CALIFORNIA PUBLIC UTILITIES COMMISSION
Safety and Enforcement Division
Wildfire Safety and Enforcement Branch

Incident Investigation Report

Incident Number: E20220905-03 (Fairview Fire)

Regulated Utility Involved: Southern California Edison Company (SCE)

Figure 3: CAL FIRE LiDAR scan of the Incident Span.¹⁹

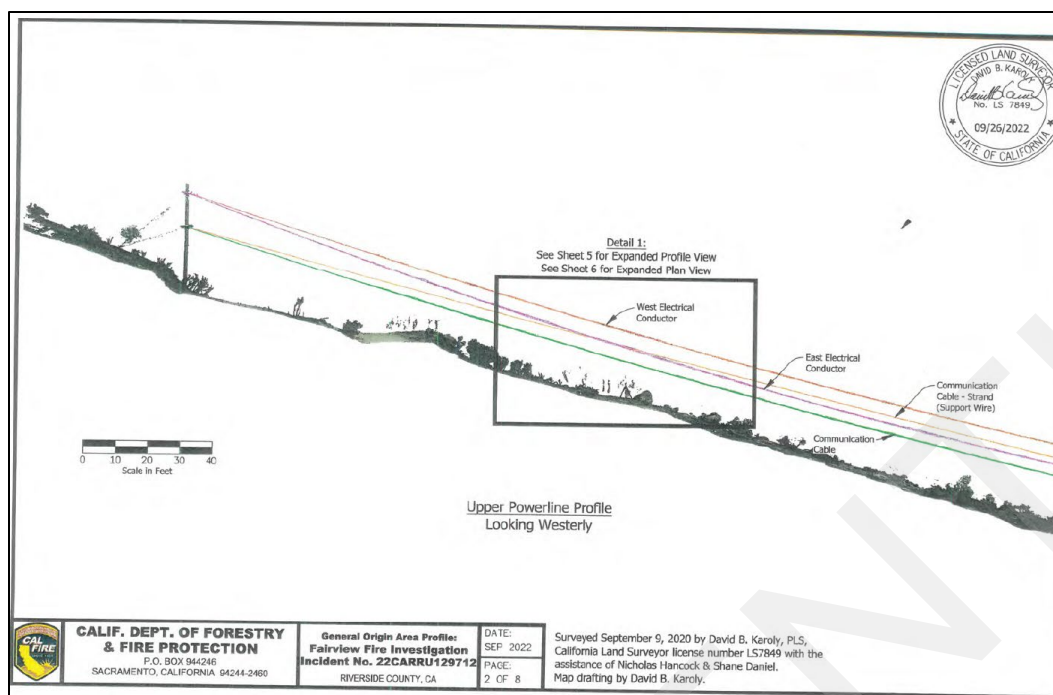
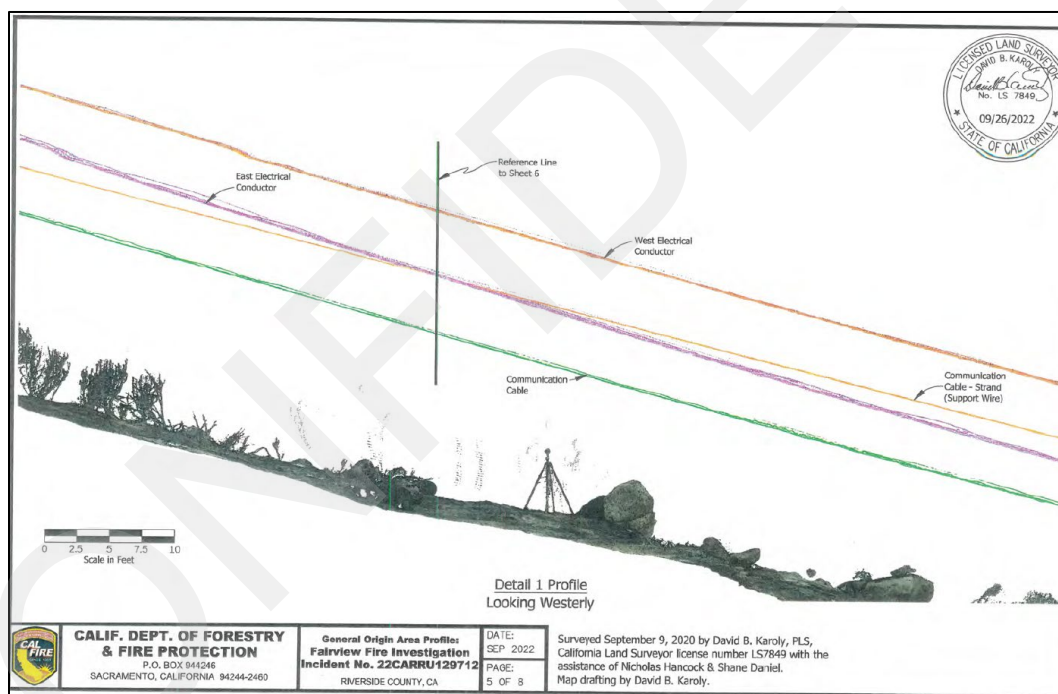
CAL FIRE performed a LIDAR scan of the area which showed the excessive sag on the eastern electrical line, as seen in Figures 3 and 4. CAL FIRE concluded that excessive sag likely led to the conductor swaying a greater distance due to the over 20 mile per hour winds in the area, which led the East phase to make contact with the Frontier Communications messenger cable and ignite the Fairview Fire.

Figure 17: SCE's East phase conductor with two scorch marks.

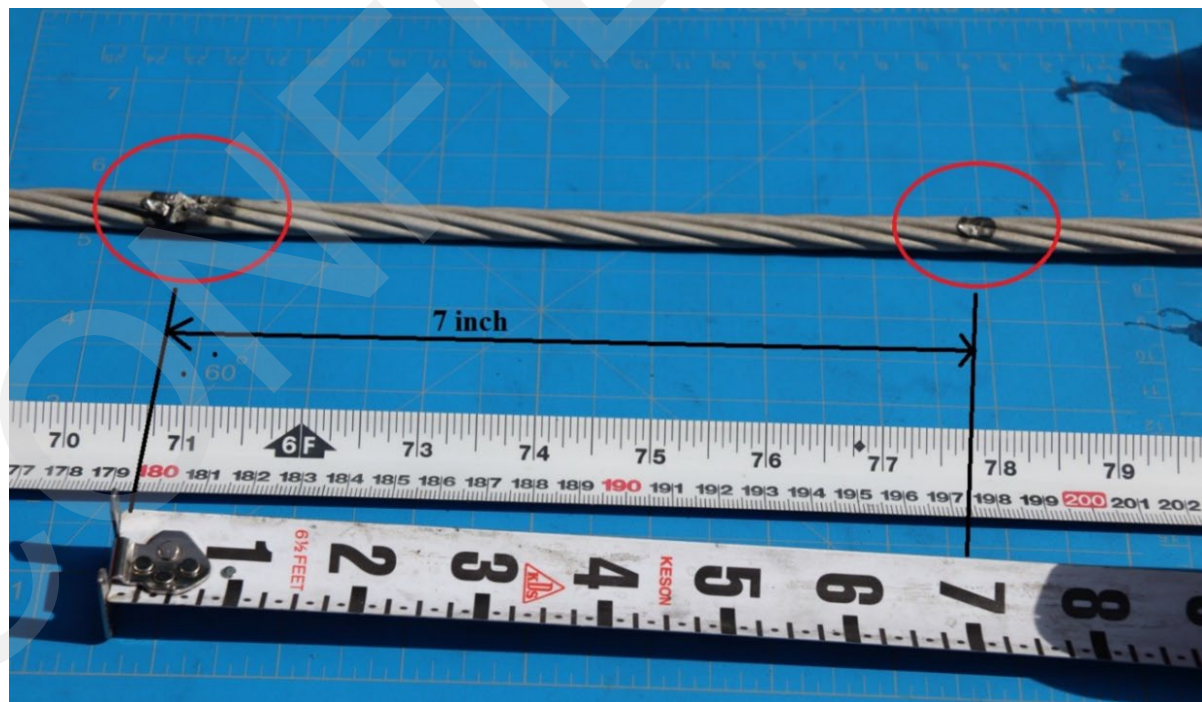
SED investigators observed CAL FIRE staff unwrap the areas of interest for all parties to inspect and photograph. As shown in Figure 17 below, SCE's East phase conductor displayed two distinctive scorch marks consistent with arcing and/or electrical damage spaced approximately seven inches apart.

Figure 18: Detailed view of one of the scorch marks on SCE's East phase conductor showing missing metal.

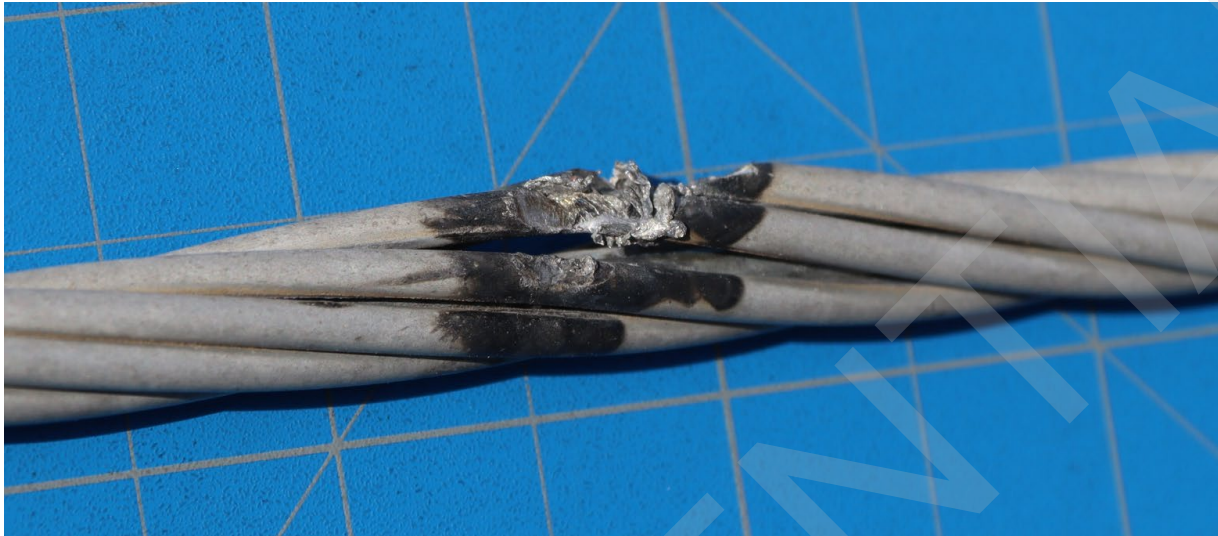
Figure 18 below shows a close-up of the damaged area on SCE's East phase conductor. In this photo, metal from the woven conductor strands appears to have melted off and dark discoloration consistent with arcing appears all around the area.

Figure 19: Frontier Communications' messenger cable exhibiting two distinct scorch marks.

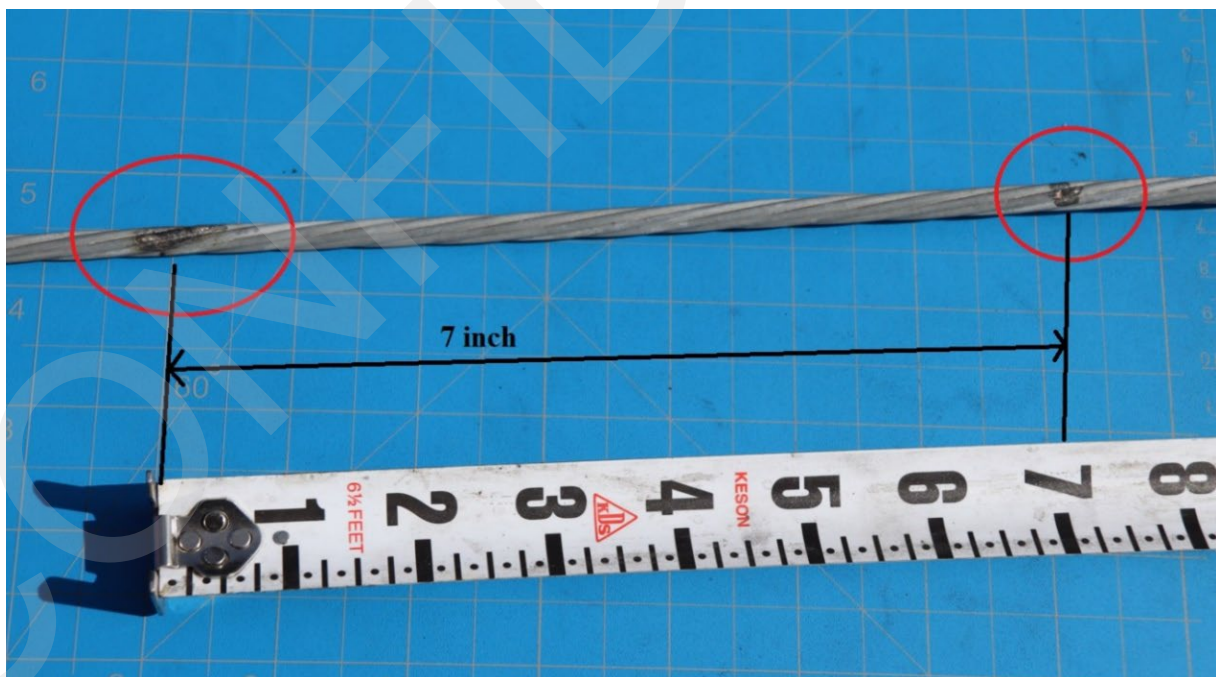
SED investigators observed similar black marks on the Frontier Communications messenger cable, as shown below in Figure 19 below. The black marks on the messenger cable were also spaced seven inches apart just like the black scorch marks seen on SCE's East phase conductor.

The scorch marks and visible damage seen on both SCE's East phase conductor and Frontier Communications' messenger cable are consistent with electrical arcing damage.

Figure 21: SCE provided a photo of the phase 1B conductor showing damaged areas.

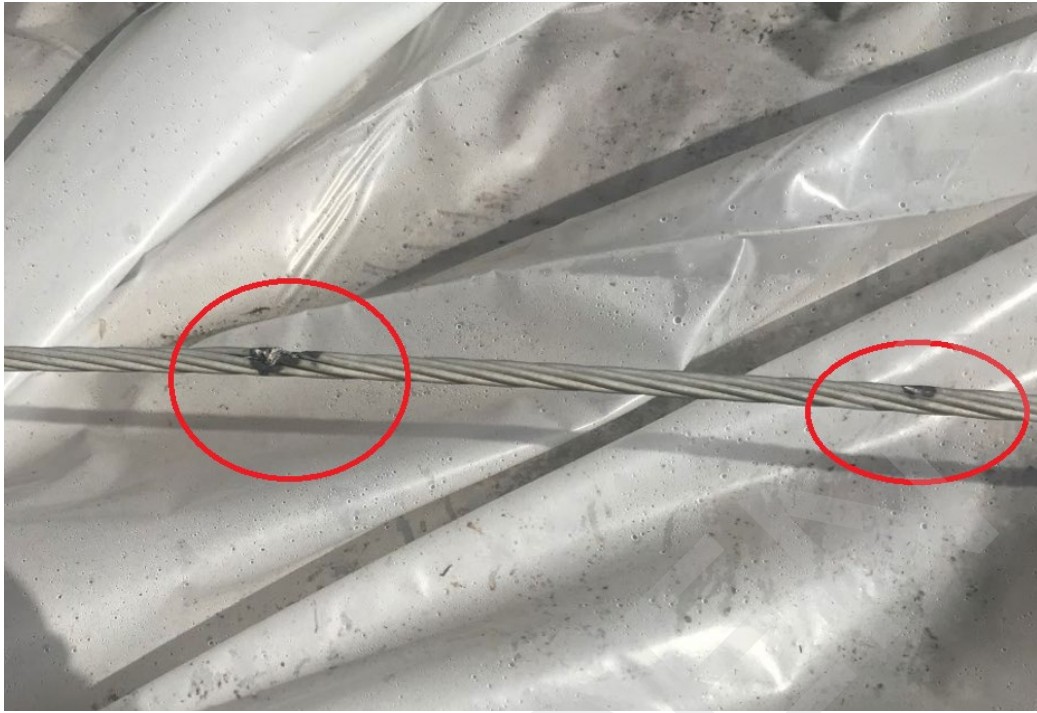
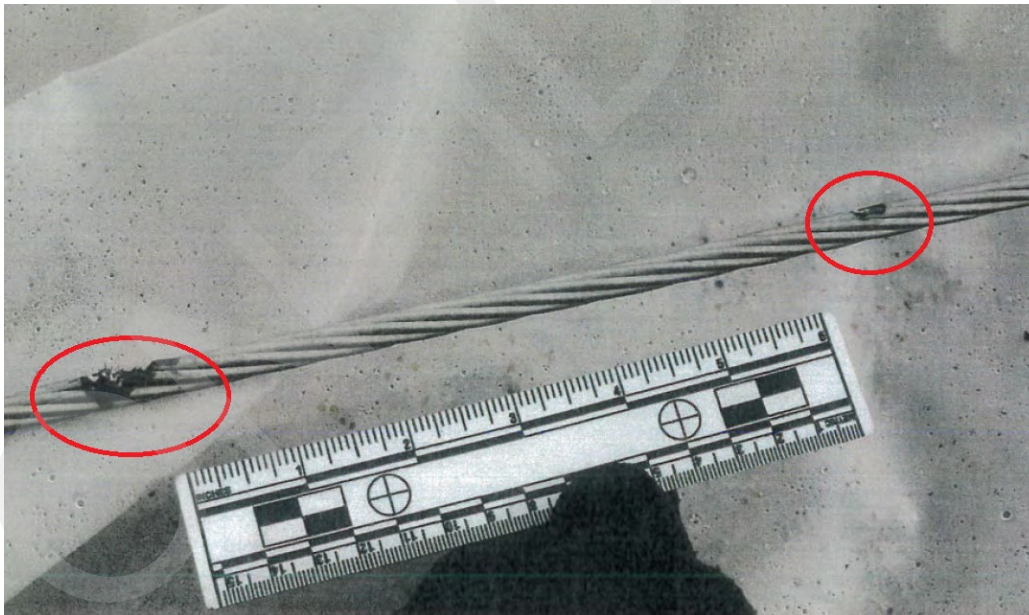
Figures 21 and 22 below both show photos of SCE's phase 1B conductor. Both sets of photos show a similar black scorch mark damage and location (circled red) on the phase 1B conductor. SCE provided the photo shown in Figure 21 but did identify and label the conductor. SED

identified a similar photo (See Figure 22) in the CAL FIRE investigation report that shows the same damage area and location on SCE's phase 1B conductor.

Figure 23: SCE provided a photo of the Frontier Communications messenger cable showing damage.⁴¹

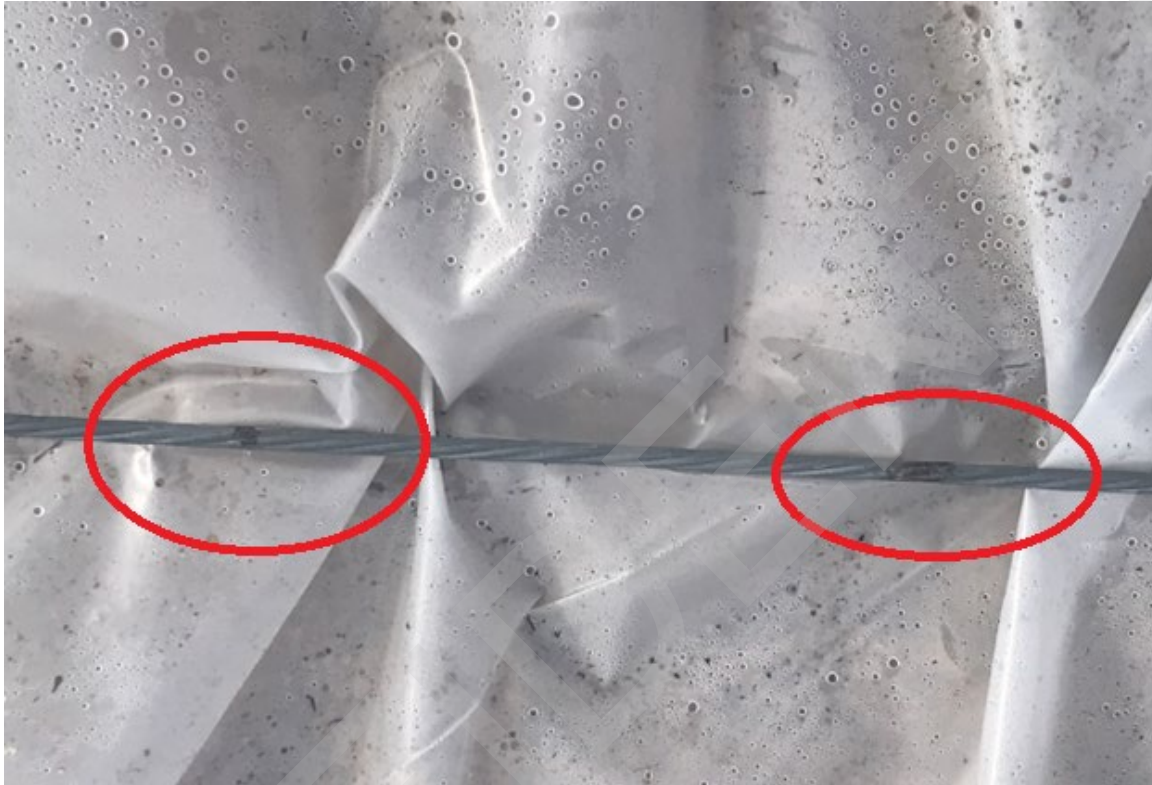
Additionally, SCE provided photos of the Frontier Communications messenger cable, which SED analyzed and matched with a similar photo seen in the CAL FIRE investigation report. Both photos (See Figures 23 and 24) show the same damage and location where SCE's phase 1B conductor most likely struck the Frontier Communications messenger cable. The red circled areas in the photos show the Frontier Communications messenger cable and signs of damage consistent with electrical arcing.

Figure 26: Profile drawing of the Incident Span based on SCE's June 2, 2020, LiDAR scan with sag measurements of the Incident Span conductors.

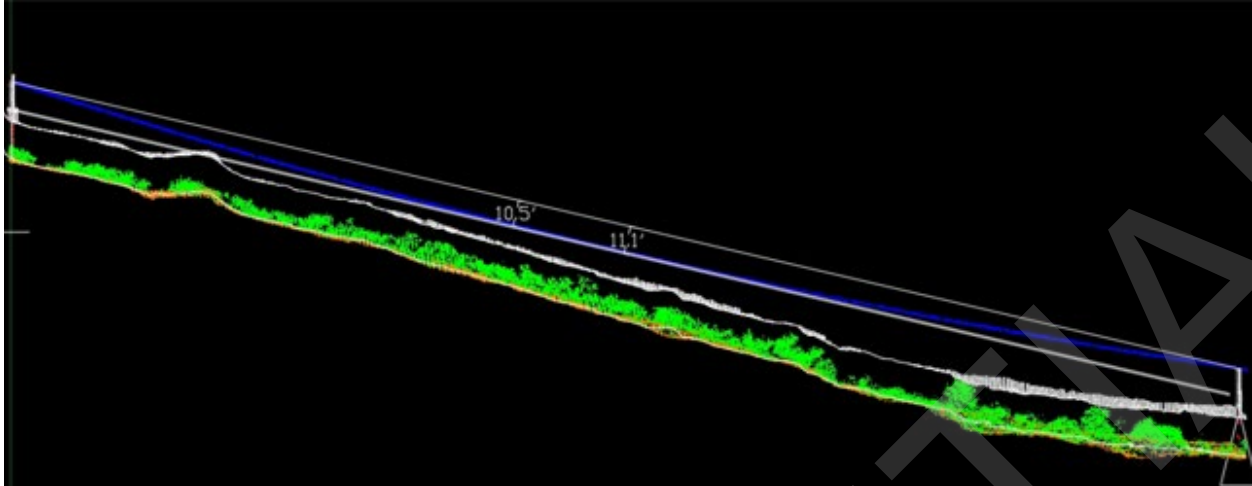
SED then asked SCE to provide the sag measurements taken in the June 2, 2020, LiDAR scan of the phase 1A and phase 1B conductors supported by Pole 220028S and Incident Pole 220029S in the Incident Span. SCE provided a profile drawing of the Incident Span between Incident Pole 220029S and Pole 220028S with 10.5 feet of sag for the phase 1A conductor and 11.1 feet of sag for the phase 1B conductor.⁴⁷ Figure 26 below shows the profile drawing of the Incident Span as well as the sag measurements of the phase 1A and phase 1B conductors provided by SCE from the June 2, 2020, LiDAR scan.

As SCE's internal construction manual sets the sag limit for the phase 1A and phase 1B conductors, SED considers any sag beyond the maximum allowable limit as excessive. Therefore, excess sag on both the phase 1A and phase 1B conductors directly violated SCE's internal sag limit for conductors as of June 2, 2020. SCE was unable to provide SED any other LiDAR scans or measurements of the Incident Span conductors prior to June 2, 2020. As a result, SED is unable to confirm the sag on the conductors prior to June 2, 2020.

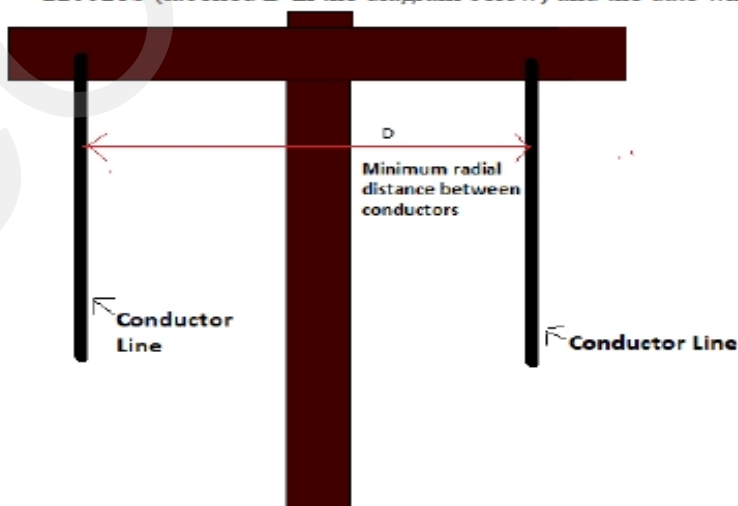
- a. Indicate the minimum distance to ground K (as shown in the diagram below) for each phase of the subject circuit between Pole 220029S and Pole 220028S and provide the date when this measurement was taken.
- b. Provide the sag dimension labeled S (as shown in the diagram below) between Poles 220029S and Pole 220028S and the date when this measurement was taken.

- c. Provide the minimum radial distance between the conductor lines on Pole 220029S and Pole 220028S (labelled D in the diagram below) and the date when this measurement was taken.

- a. Reference Diagram 8.1 above. The approximate minimum distance to ground (K) for each phase is:
 - a. Wire 1: 18.1'
 - b. Wire 2: 19.4'
- b. Reference Diagram 8.2 above. The approximate maximum sag is 10.5'.
- c. Reference Diagram 8.1 above. The approximate minimum radial distance between phases is 8.8'.

Diagram 8.1

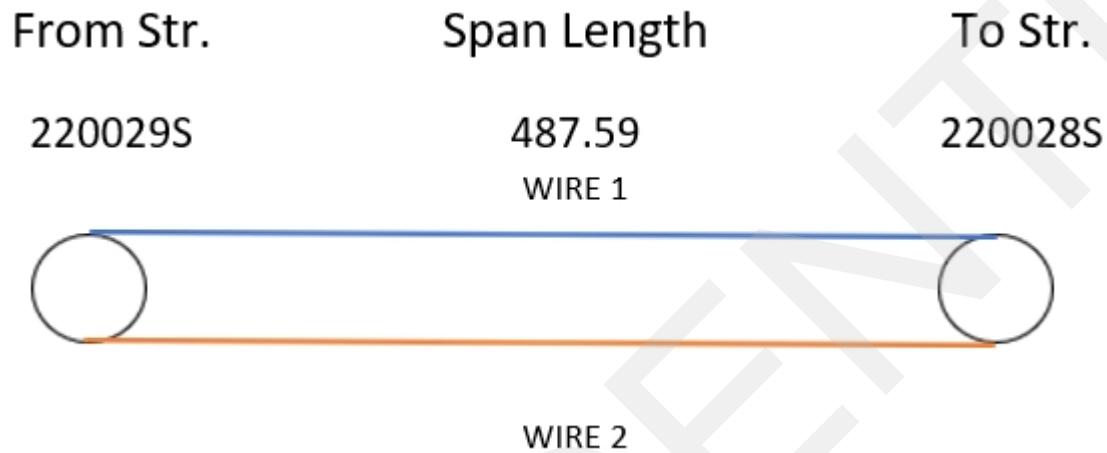
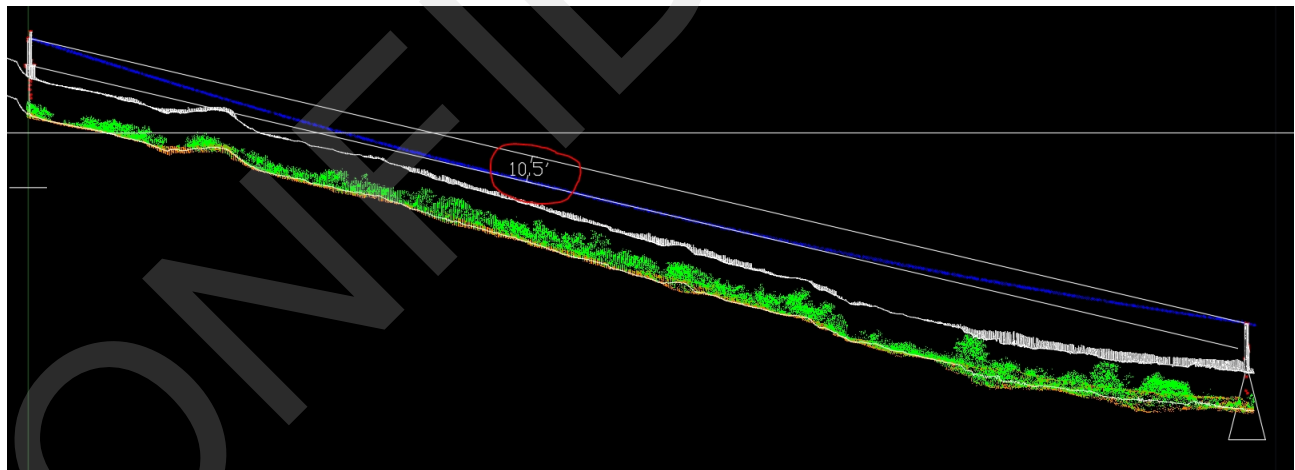
Provide sag calculations/dimensions for conductors supported between Poles 220029S and Pole 220028S based on the latest available LiDAR scan of the area. Indicate the elevation of each phase above the ground and the distance between each phase and the other phases compared to the elevations and distances required by SCE's internal procedures. Provide the date that this LiDAR data was acquired.
